HALLS MILL CORSSING SUBDIVISION, **RESUBDIVISION OF LOTS 1 & 2**

APPLICATION NUMBER 18 DATE November 1, 2012
APPLICANT Halls Mill Crossing Subdivision, Resubdivision of Lots 1 & 2
REQUEST Subdivision

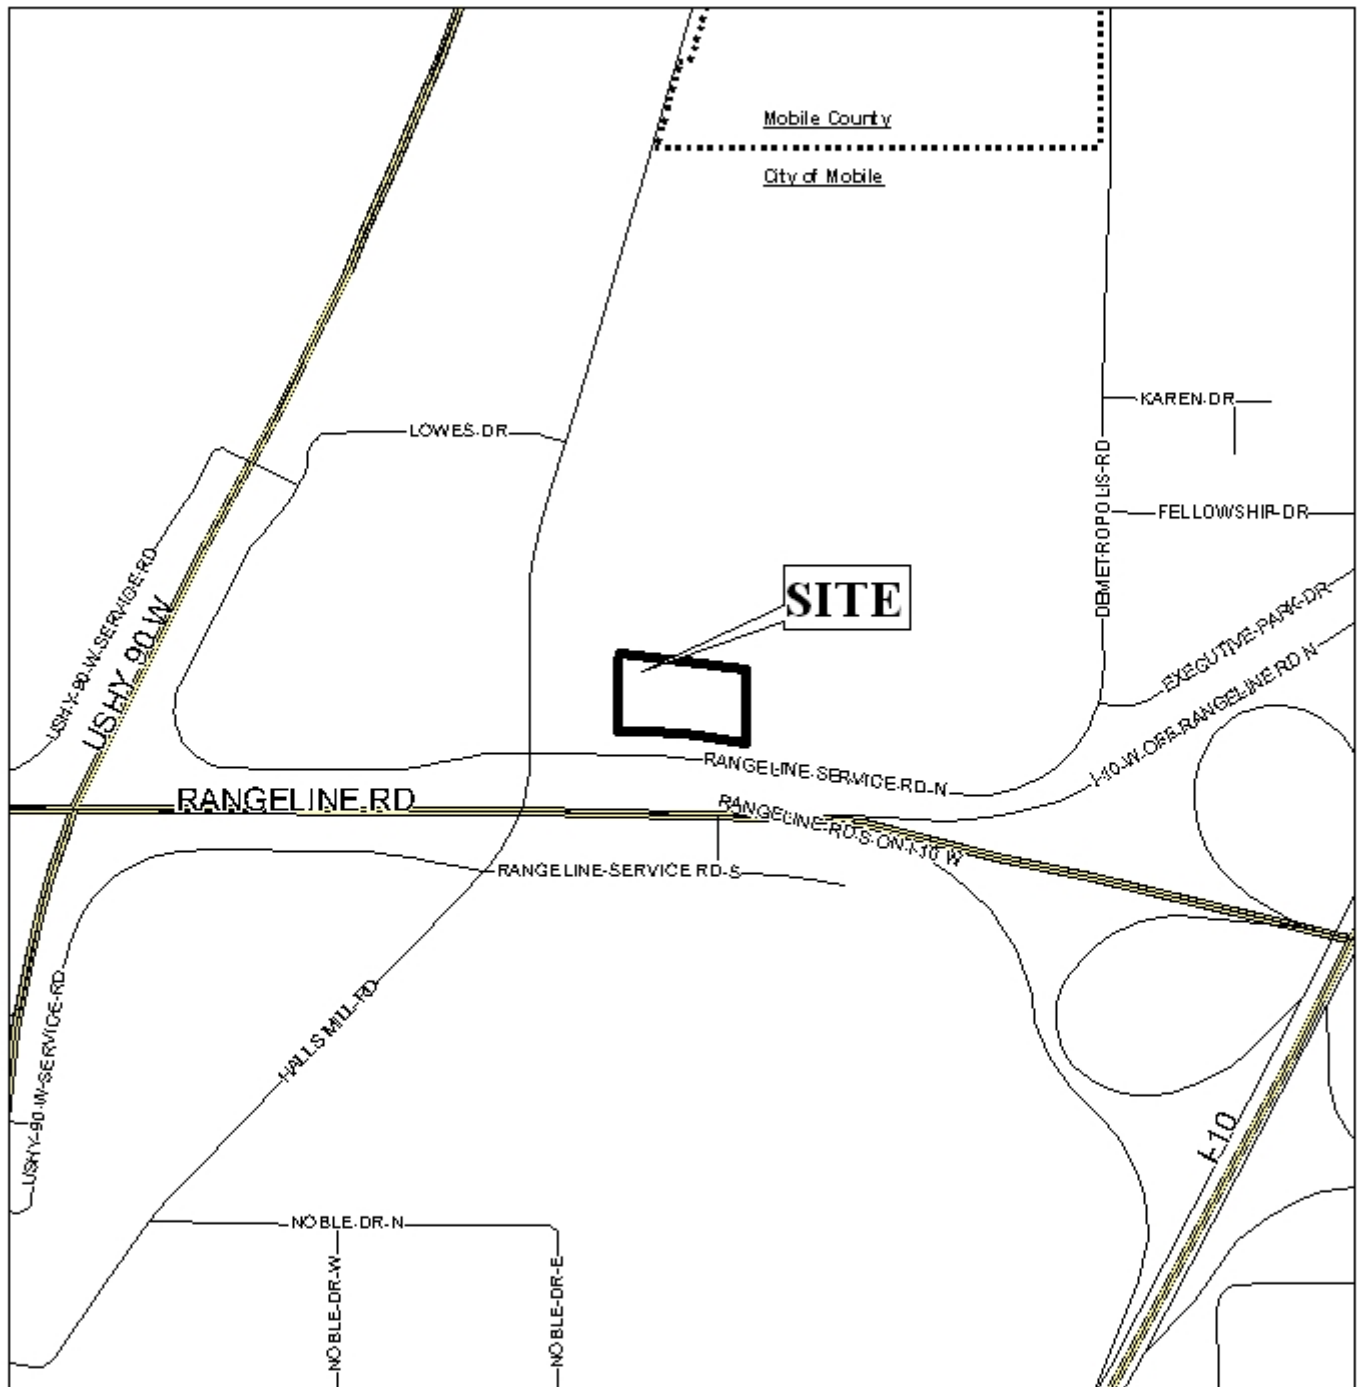
The lot sizes are labeled, and the proposed lots would exceed the minimum size requirements of Section V.D.2. of the Subdivision Regulations. The lot sizes should be retained in square feet and acres on the Final Plat, as on the preliminary plat, if approved.

The site fronts onto Rangeline Service Road North. It should be noted that Rangeline Road is a major street, which is illustrated on the preliminary plat to have a right-of-way that varies. According to the Major Street Plan, Rangeline Road should have a right-of-way width of 300 feet. The preliminary plat should be revised to illustrate a minimum of 150' from the centerline of Rangeline Road, with dedications made as necessary.

The 25-foot minimum building setback line, required in Section V.D.9., is illustrated and labeled on the preliminary plat. If approved, the 25-foot building setback line should be retained on the

Final Plat. A 50' minimum building setback line is indicated on the preliminary plat for Lot 1 and a portion of Lot 2, and should also be illustrated on the Final Plat. It should be noted that the 50' setback exceeds the 25' minimum building setback required by the Subdivision Regulations.

Lot 1 has less than 200' of street frontage, and Lot 2 has more than 200' of street frontage therefore Lot 1 is limited to one curb cut to Rangeline Service Road North, and Lot 2 is allowed two curb cuts to Rangeline Service Road North, with driveway size, location and design to be approved by ALDOT and Traffic Engineering, and conform to AASHTO standards.

Lot 2 is slightly unusually shaped with the inclusion of the 25' drainage and utility easement at the rear of the lot. There are not any unusually shaped lots in the area, and would therefore be out of character. However, the fact that the unusual shape is due to the inclusion of a drainage and utility easement makes a waiver of Section V.D.1. of the Subdivision Regulations appropriate.

There is a common area that was created to serve these lots as part of the 2008 Halls Mill Crossing Subdivision which is located to the East of Lot 2. The Final Plat should be revised to include this common area, with a note stating that the maintenance of the common area is the responsibility of the property owners and not the City of Mobile. The addition of the common area will not result in any additional mailing labels or fees to be processed.

- 1) revision to illustrate 150' from the centerline of Rangeline Road or dedication to provide 150' from the centerline of Rangeline Road;
- 2) illustration of the 25' minimum building setback line along Rangeline Service Road North adjusted to be measured from required dedication;

- 3) retention of the lot size in square feet and acres;
- 4) compliance with Engineering comments (*The following comments should be addressed prior to acceptance and signature by the City Engineer: 1. Provide all of the required information on the Final Plat (i.e. signature blocks, signatures, certification statements, legal description, required notes). 2. A signature block and signature for the Traffic Engineering Department shall be placed on the Final Plat.*);

- 6) inclusion of the common area to the East of Lot 2;
- 7) placement of a note stating that maintenance of the common area is the responsibility of the property owners and not the City of Mobile;

- 8) placement of a note stating that there will be no structures in the 25' drainage and utility easement;

- 9) placement of a note on the Final Plat stating Lot 1 is limited to one curb cut to Rangeline Service Road North, and Lot 2 is allowed two curb cuts to Rangeline Service Road North, with driveway size, location and design to be approved by ALDOT and Traffic Engineering, and conform to AASHTO standards; and
- 10) placement of a note on the Final Plat stating that approval of all applicable Federal, state and local agencies is required for endangered, threatened or otherwise protected species, if any, prior to the issuance of any permits or land disturbance activities.
